SERVICE BULLETIN

B-004 April 1995

NONCOMPLIANCE RECALL 0801 – P/M WHEEL LABELS

Figure 1. Label Placement

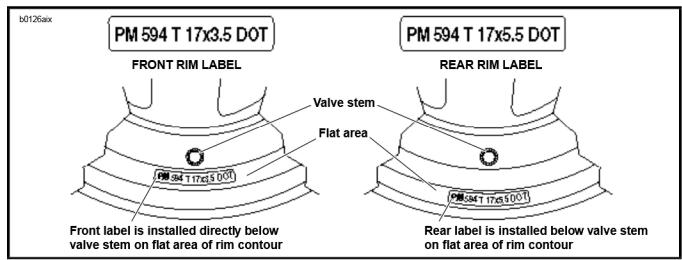
Buell Motorcycle Company has determined that the identification used on the tire rims on certain 1995 S2-Thunderbolts fails to conform to Federal Motor Vehicle Safety Standard No. 120 (tire selection and rims).

The P/M polished aluminum tire rims do not include the required weather side label markings designating the rim's nominal dimensions, rim size designation and Buell's DOT certification that the rim complies with all applicable motor vehicle safety standards. In addition, the rim does not include the labels which identify the rim manufacturer and the month and year of production.

See Figure 1. In order to meet federal regulations, a label must be placed on the front and rear rim of each affected motorcycle. Follow the instructions below.

Front and rear rim labels are not interchangable. Match each label to its corresponding rim as shown in Figure 1.

- 1. Clean rim surface at locations shown in Figure 1.
- Remove adhesive backing from front label (PM 594 T 17x3.5 DOT). Install front label directly below valve stem on flat area of rim contour.
- Remove adhesive backing from rear label (PM 594 T 17x5.5 DOT). Install rear label below valve stem on flat area of rim contour.

Figure 2. Label Placement

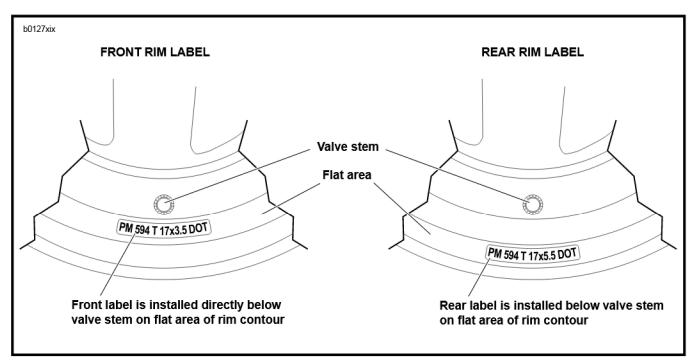
The tire rims do not include the required weather side label markings designating the rim's nominal dimensions, rim size designation and Buell's DOT certification that the rim complies with all applicable motor vehicle safety standards. In addition, the rim does not include the labels which identify the rim manufacturer and the month and year of production.

See Figure 1. In order to meet federal regulations, a label must be placed on the front and rear rim of each affected motorcycle. Follow the instructions below. Should you wish to have your dealer affix the labels for you, please take your motorcycle back to your selling dealer for this purpose, at no charge to you.

1. Clean rim surface at locations shown in Figure 2.

- Remove adhesive backing from front label (PM 594 T 17x3.5 DOT). Install front label directly below valve stem on flat area of rim contour.
- Remove adhesive backing from rear label (PM 594 T 17x5.5 DOT). Install rear label below valve stem on flat area of rim contour
